LIBERTY SUBDIVISION

APPLICATION NUMBER 18 DATE February 7, 2008

REQUEST Subdivision

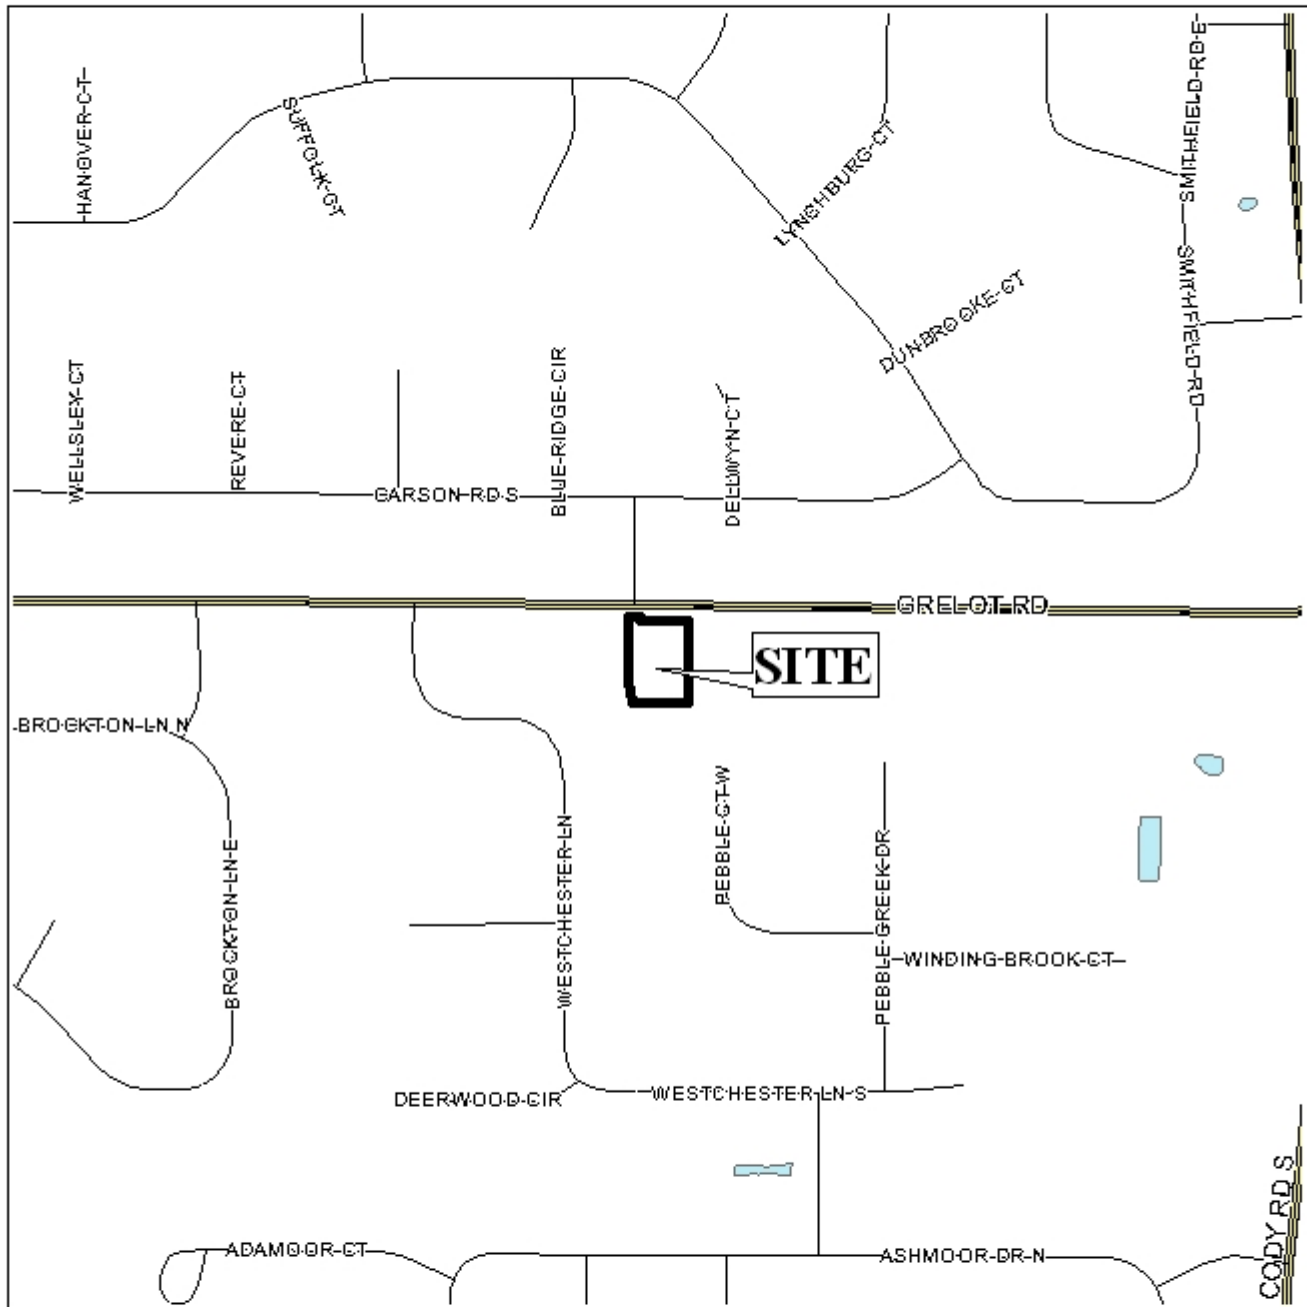
The proposed lot would have approximately 125' of frontage along Grelot Road. As a means of access management, a note should be placed on the final plat stating that Lot 1 is limited to one curb cut to Grelot Road, with the size, location, and design to be approved by County Engineering and conform to AASHTO standards.

No building setback line is indicated on the plat; therefore, the plat should be revised to indicate a minimum 25' building setback line along Grelot Road.

No lot size is indicated on the plat; therefore, the plat should be revised to label all lots with their size in square feet, or a table should be provided furnishing the same information.

The owner of the major metes-and-bounds parcel involved in this subdivision has acquired a large portion of the adjacent smaller metes-and-bounds parcel to the West (Parcel R022809311000011) which was owned by the adjacent neighbor to the South on Lot 19, Westchester Place Subdivision, First Addition. The Southern portion of the parcel was retained by that owner which has created a separate land-locked parcel. Therefore; the land-locked remainder of Parcel R022809311000011 should be included in this subdivision, either as part of Lot 1, or as an addition to Lot 19, Westchester Place Subdivision, First Addition, which would then require this application to be a two-lot subdivision. In either case, a deed of sale of the larger portion or all of Parcel R022809311000011 should be furnished with this application.

- 1) revision of the plat to eliminate the land-locked parcel which would be created at the Southern end of Parcel R022809311000011, either by inclusion of that portion into Lot 1, or as an addition to Lot 19, Westchester Place Subdivision, First Addition, as a two-lot revision to this application;
- 2) revision of the plat to label each lot with its size in square feet, or the provision of a table on the plat furnishing the same information; and
- 3) provision of a deed of sale of the Northern portion of Parcel R022809311000011 for a two-lot subdivision, or the entire parcel for a one-lot subdivision.
